## ADDENDUM

Date February 2, 2024

Re Addendum No. 3 to the Construction Documents for:

Dorthea Dix Psychiatric Campus  
Pooler Pavilion Abatement  
Bangor, Maine  
Project No. 23134

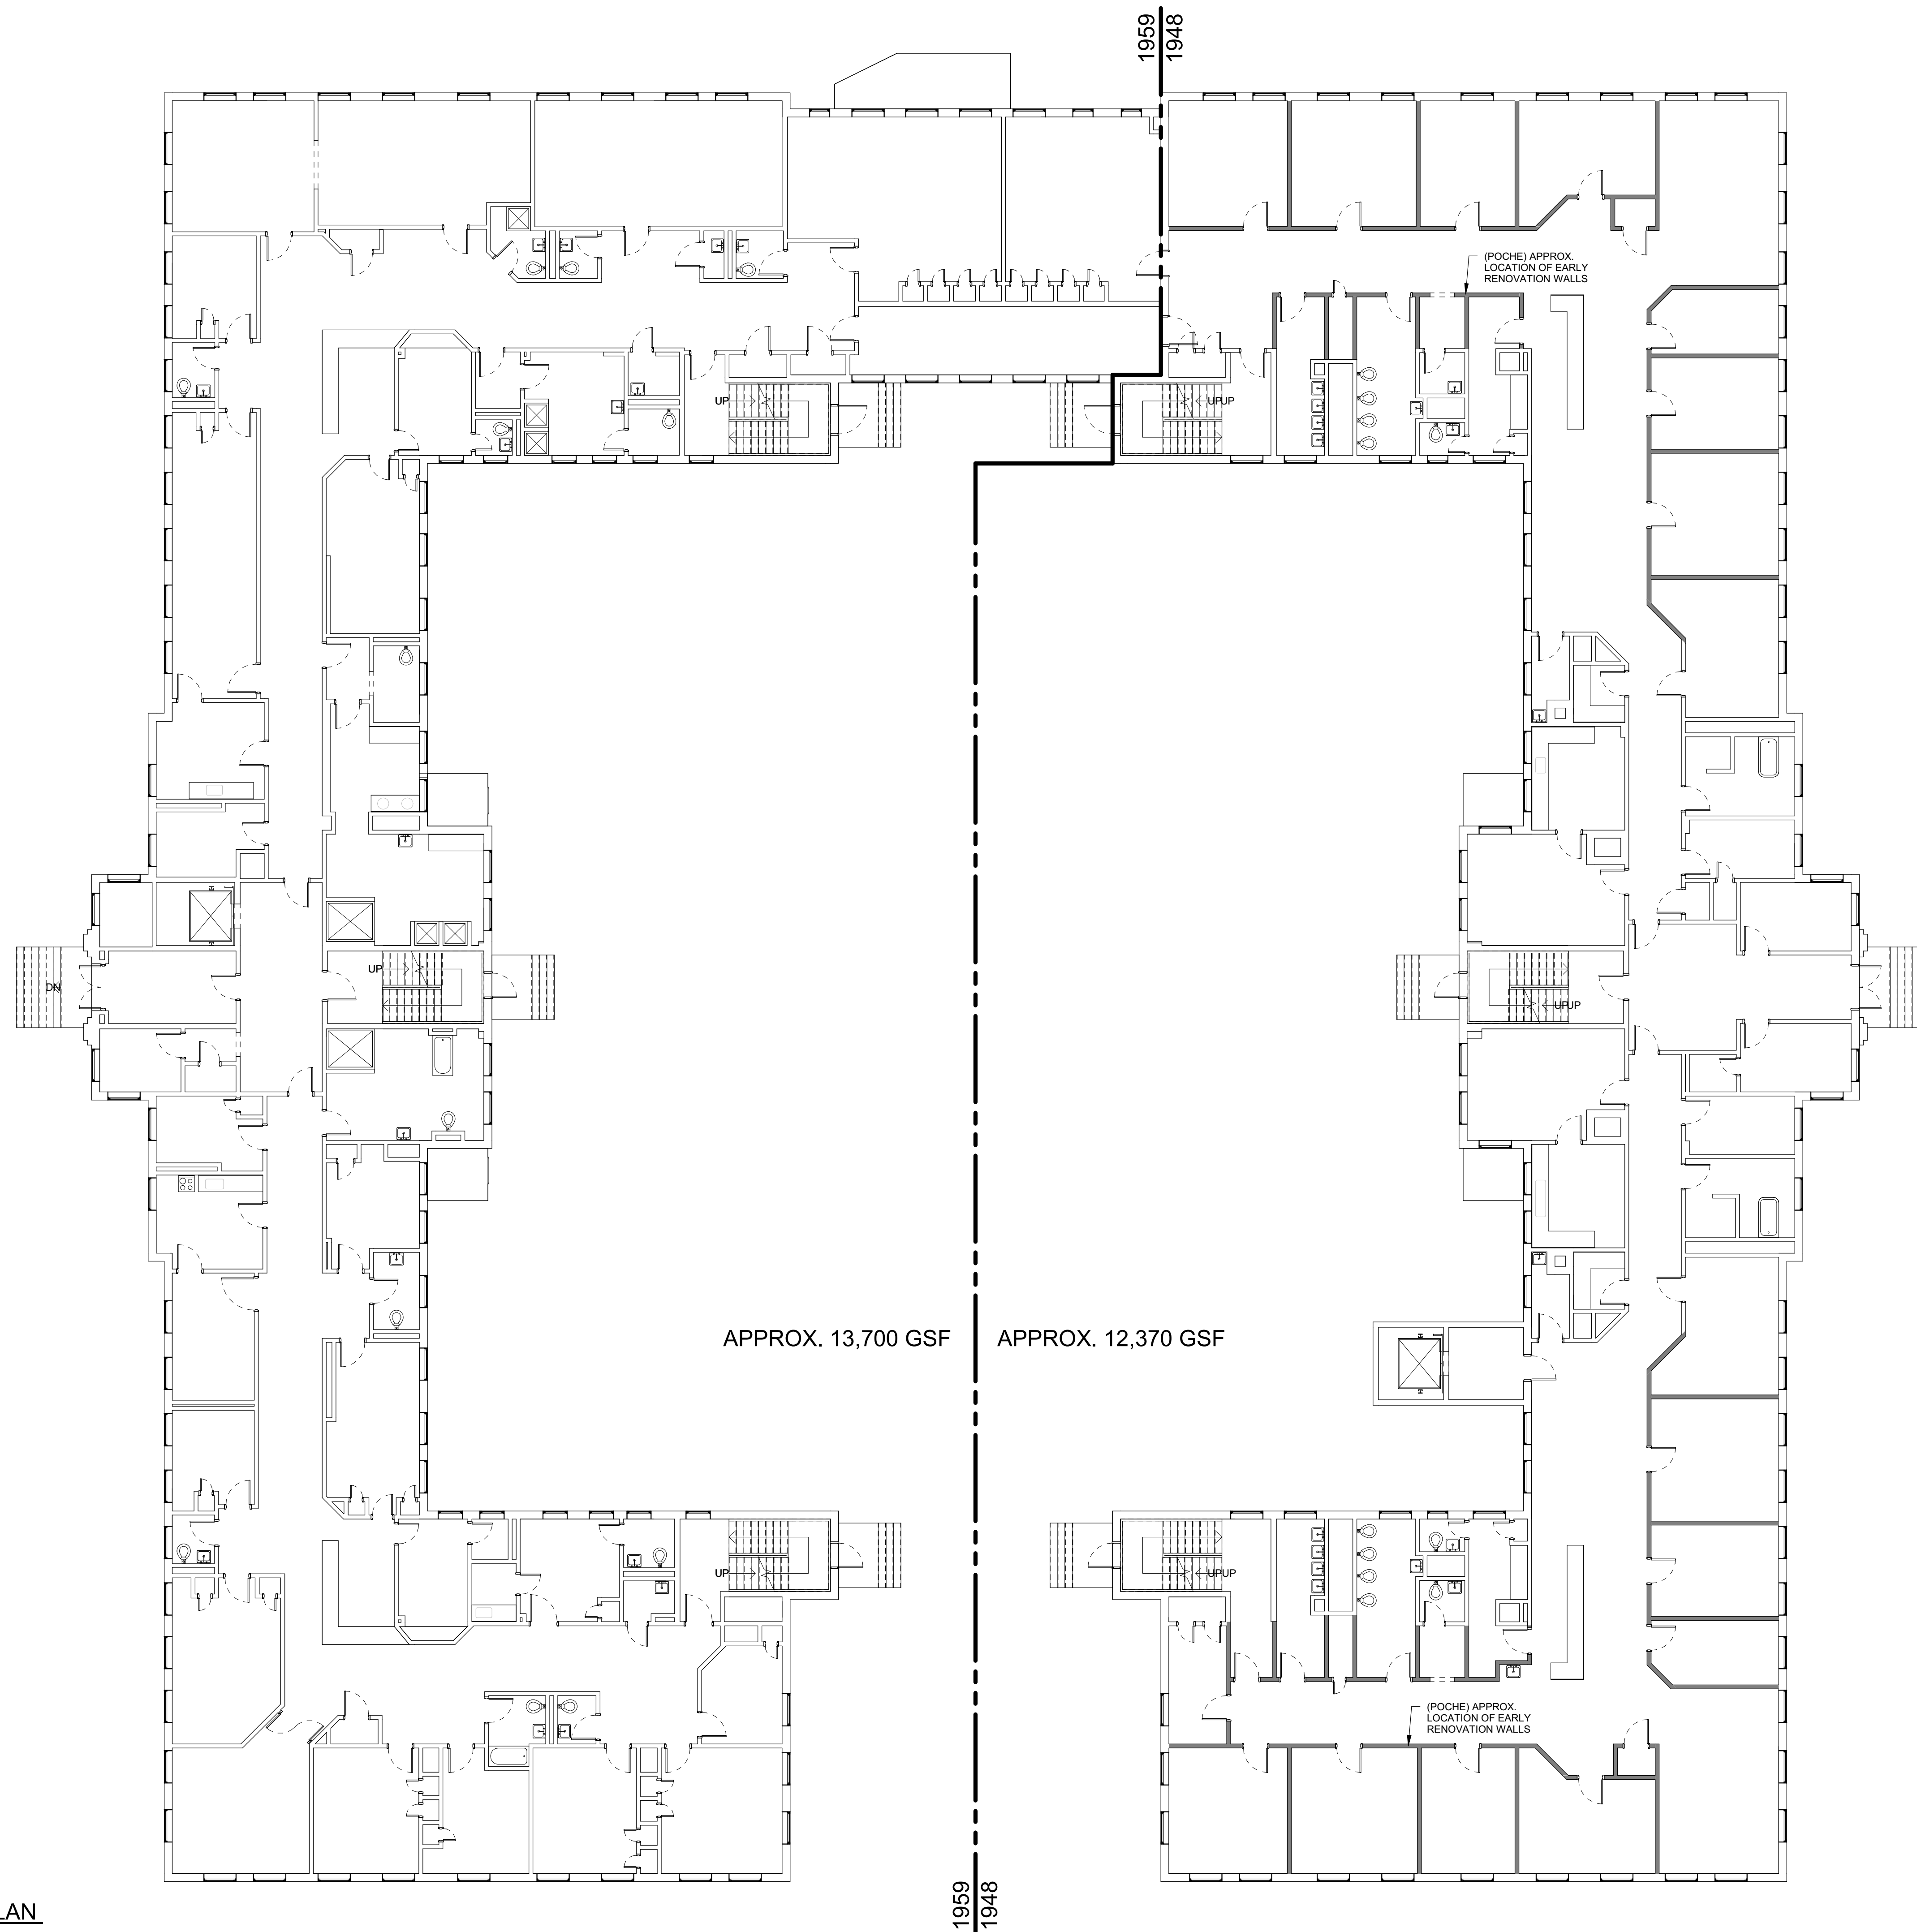
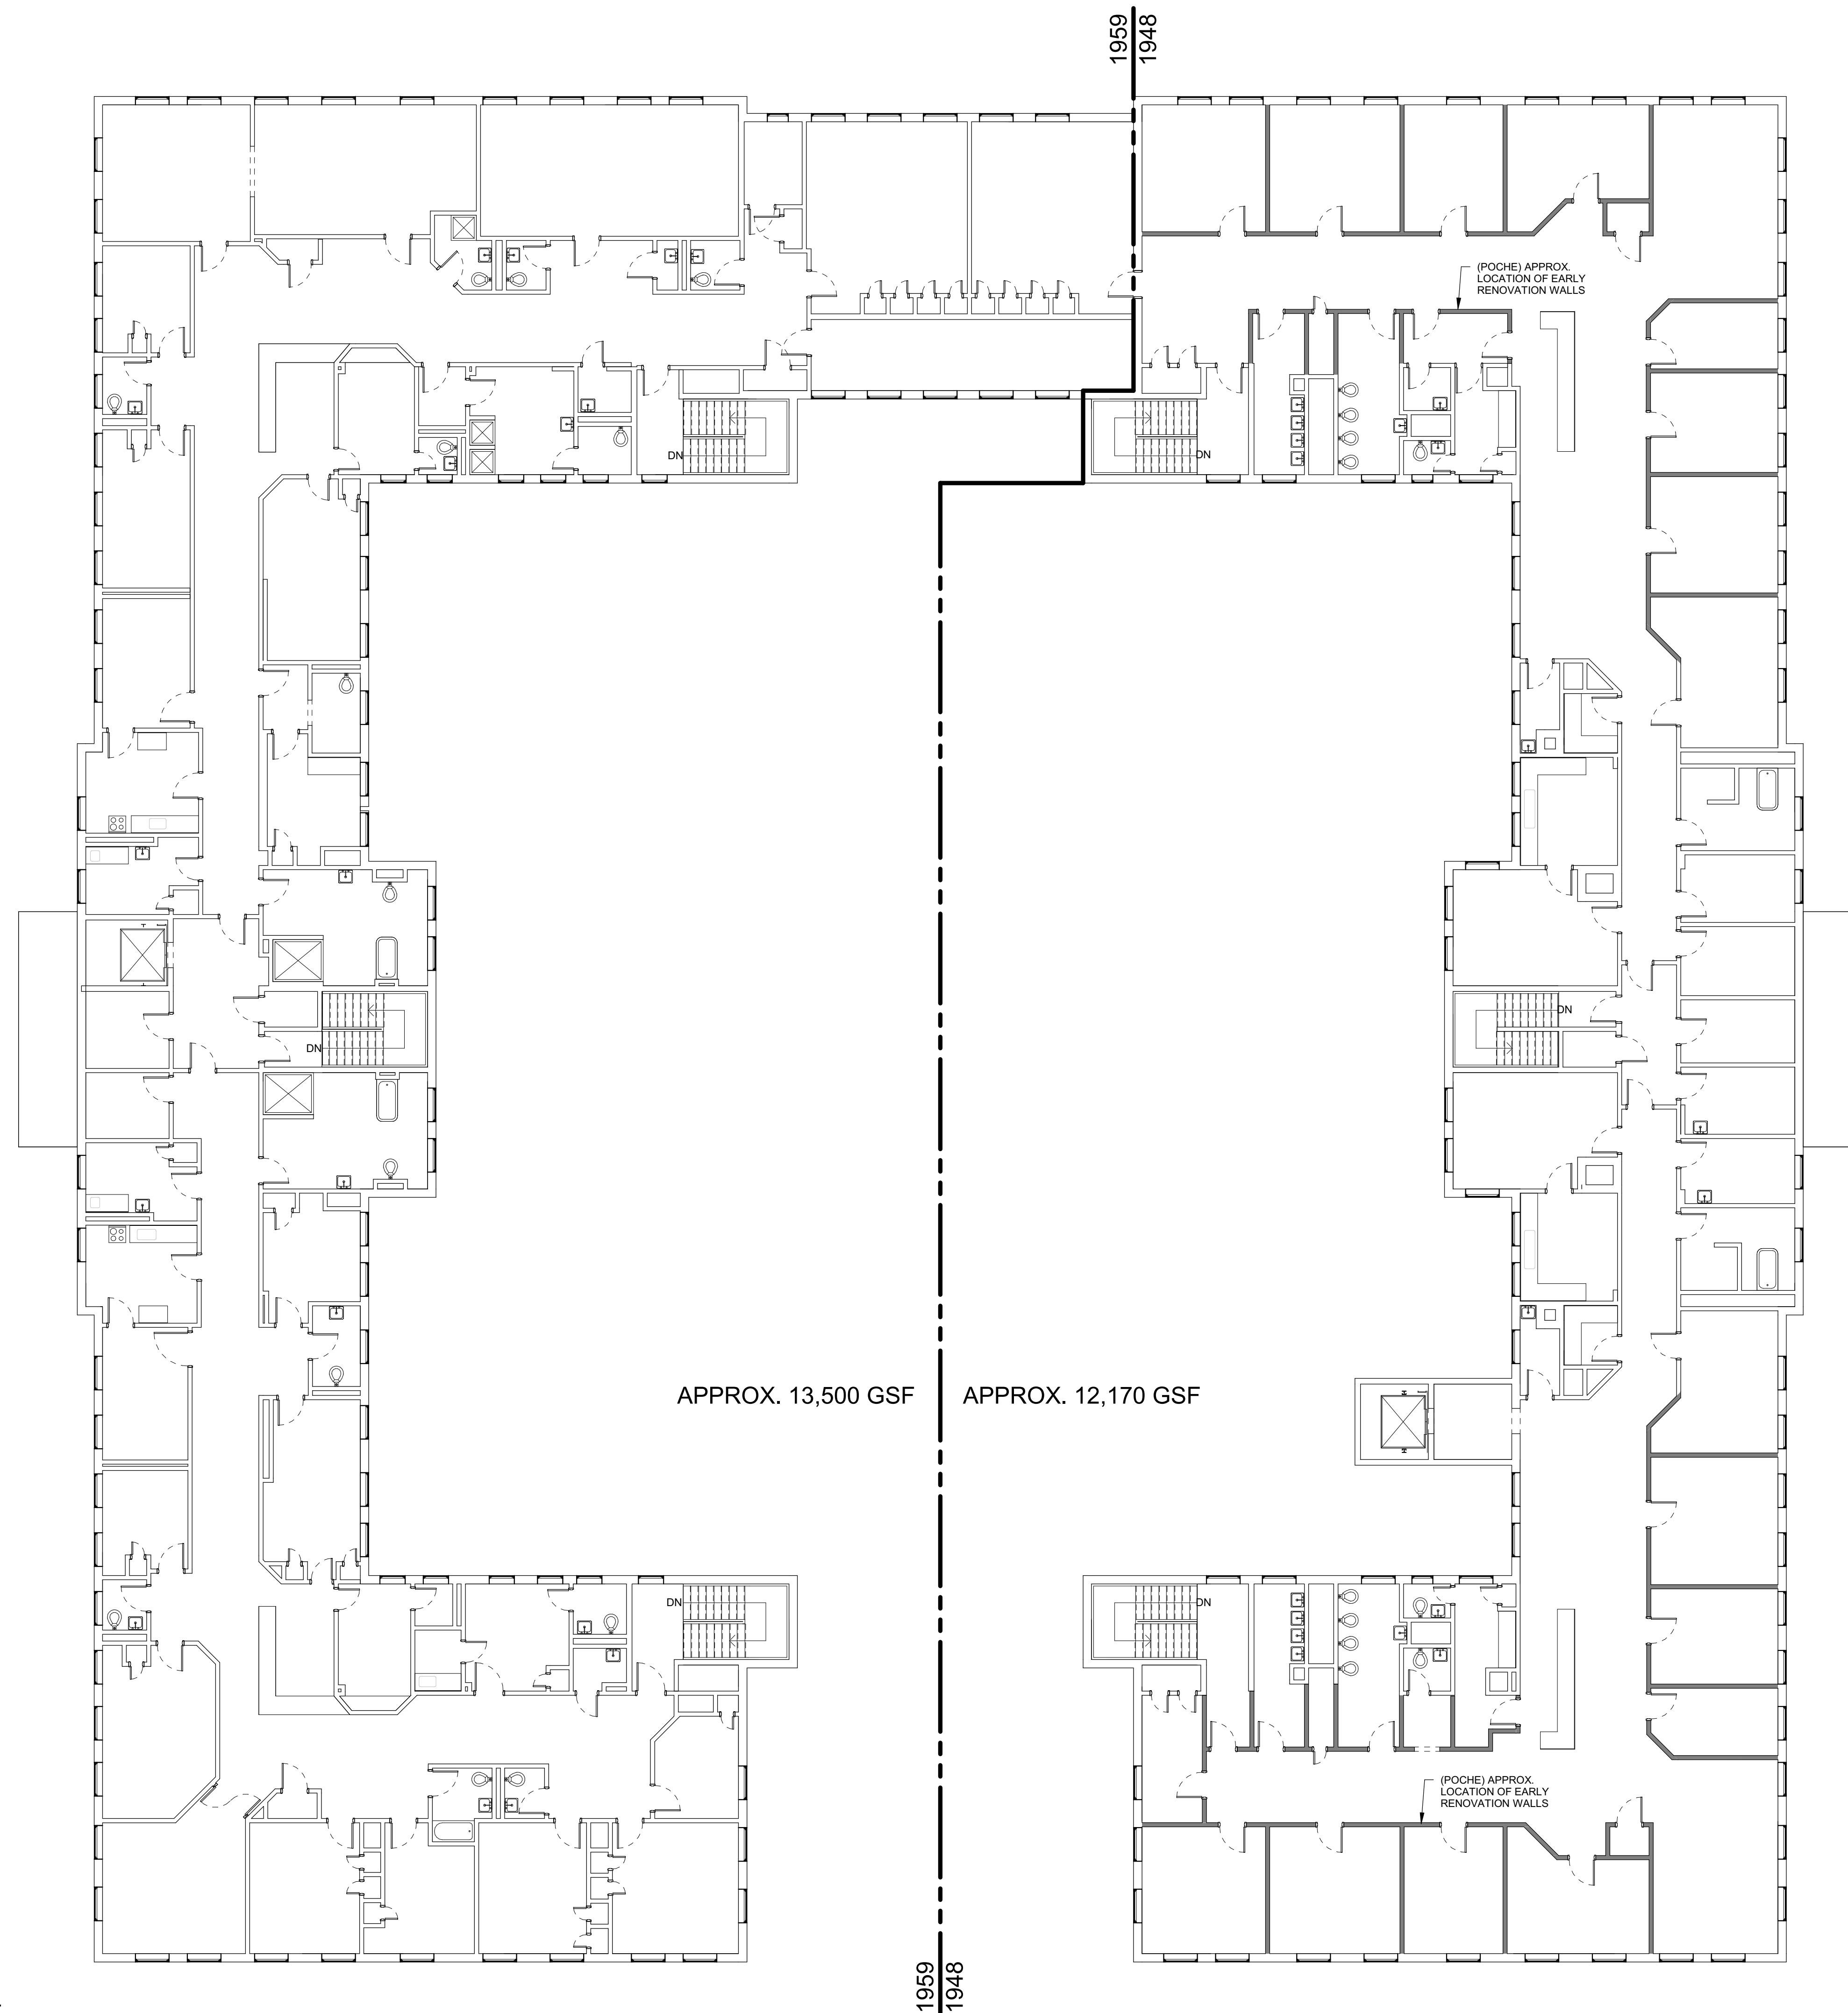
Q6: Please confirm permanent power will be provided at no charge to the contractor.

Q7: Water is required for MDEP asbestos worker decontamination showers. Will any water service be available for this project?

Q18: Will the Owner perform grubbing and cut back of the excess vegetation & trees to allow for access to the outside of the building (i.e.. windows, doors, etc.) requiring exterior caulking removal?

**See notation for location of proposed temporary electrical patch panel on floor plan reference drawings provided with this addendum.**

**See notation for location of proposed temporary domestic water connection on the floor plan reference drawings provided with this addendum.**

**A18: No. Site and building to be considered 'as is'. Existing vegetation in immediate proximity to the building and in the courtyard does not need to be preserved. See site diagram in attached floor plan documents issued for reference with this Addendum.**
